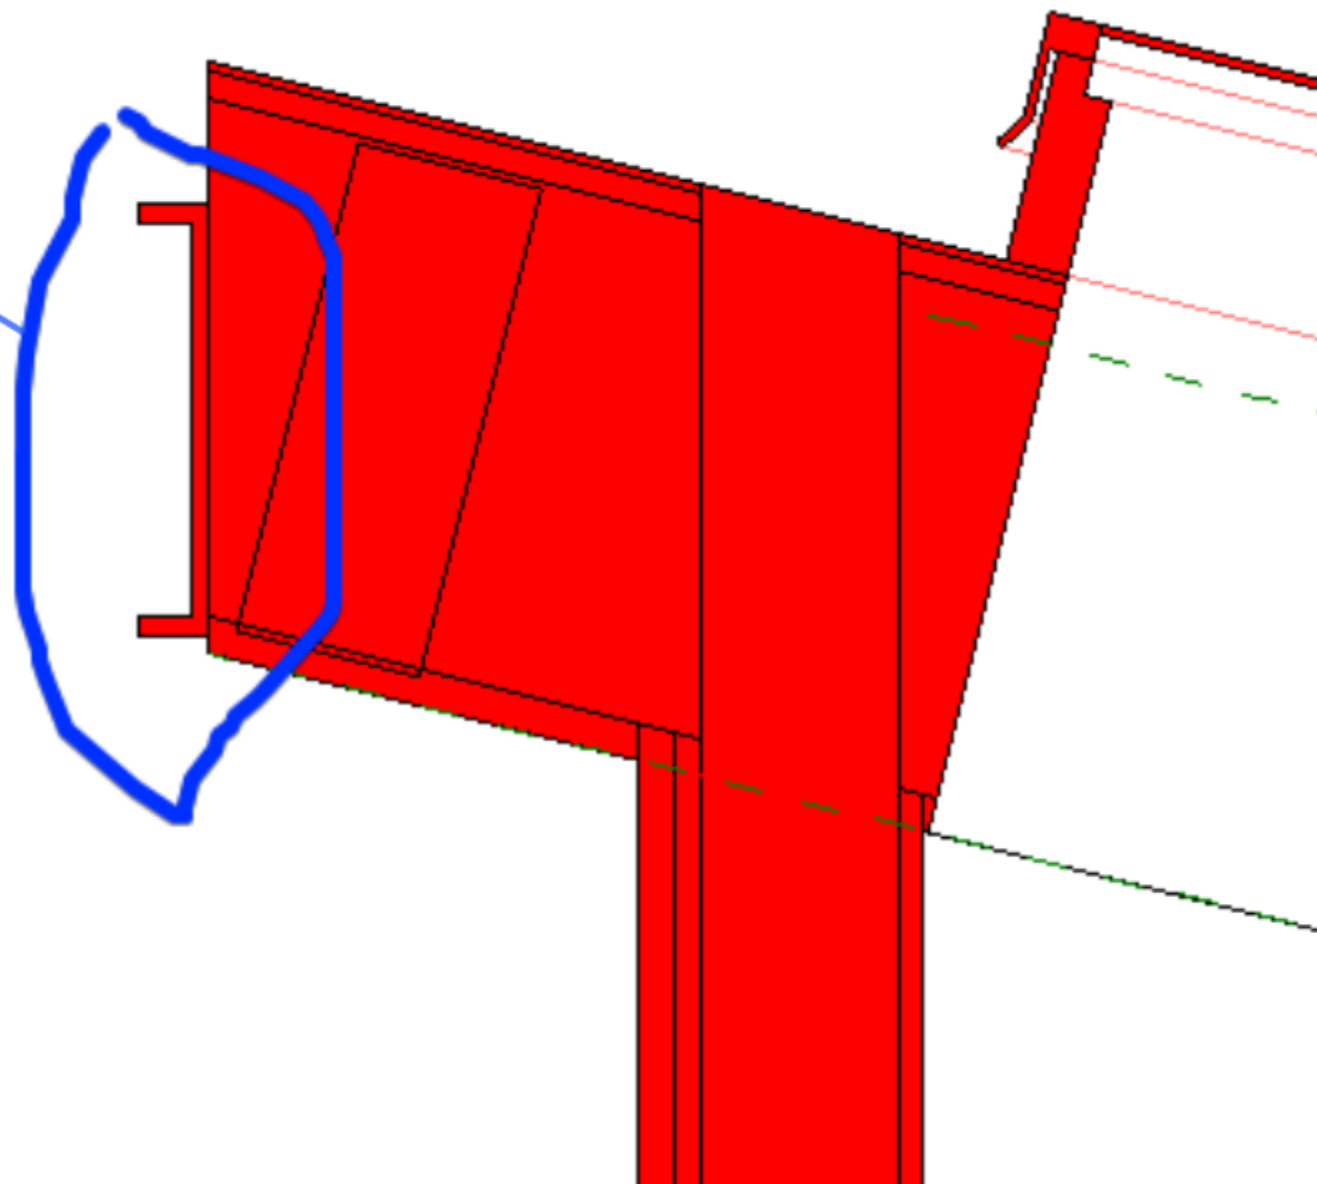
I noticed this type of detail at the eaves.
Does this happen at all the eaves?
Is it a C channel? or Brake Metal?
Galv? Painted?

at 7" wide, this
beam is wider
than the 2x6 wall.

That okay?

Also, Do you want the
top of this
beam to align
with the top of
the floor joists?

Is this
a stucco
ceiling?

this is from a really
old model... please
make sure you use
the latest revit
model I sent you

new struct model
does not have this c
channel.

please make sure
you use the latest
revit model shared
with you on
11/30/2018

you can also load
the structural model
into our latest revit
model.

reload new struct
model for alignments

all ceilings on
exterior are either
stucco or coulson
cedar.

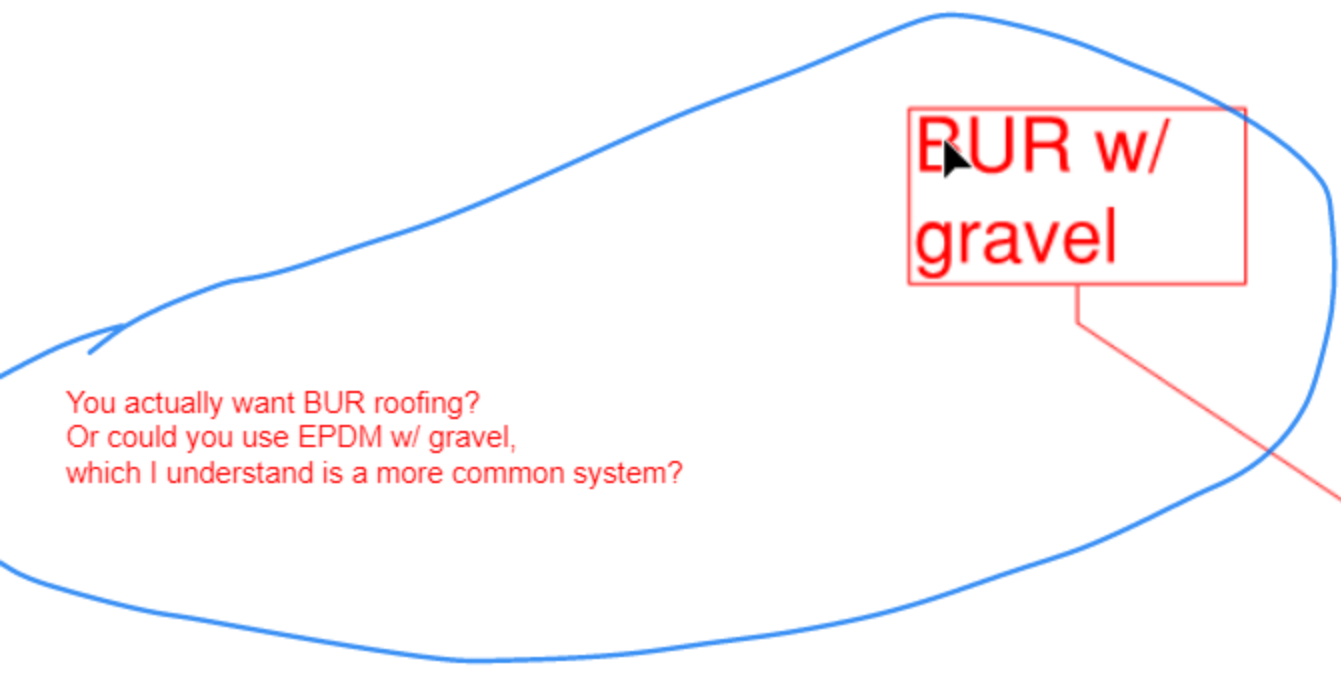
can we assume, at
these ext. conditions,
where the revit floor
object has a
'Gypsum Wall Board'
layer, that it is
stucco?

Is the following the floor assembly here?

- 3/4" HARDWOOD FLOOR
- 3/4" CDX PLYWOOD
- 14" DEEP TJI
- 5/8" GYP BD?

You actually want BUR roofing?
Or could you use EPDM w/ gravel,
which I understand is a more common system?

yes.

yes

we confirmed with
the contractor to
use BUR over
gravel
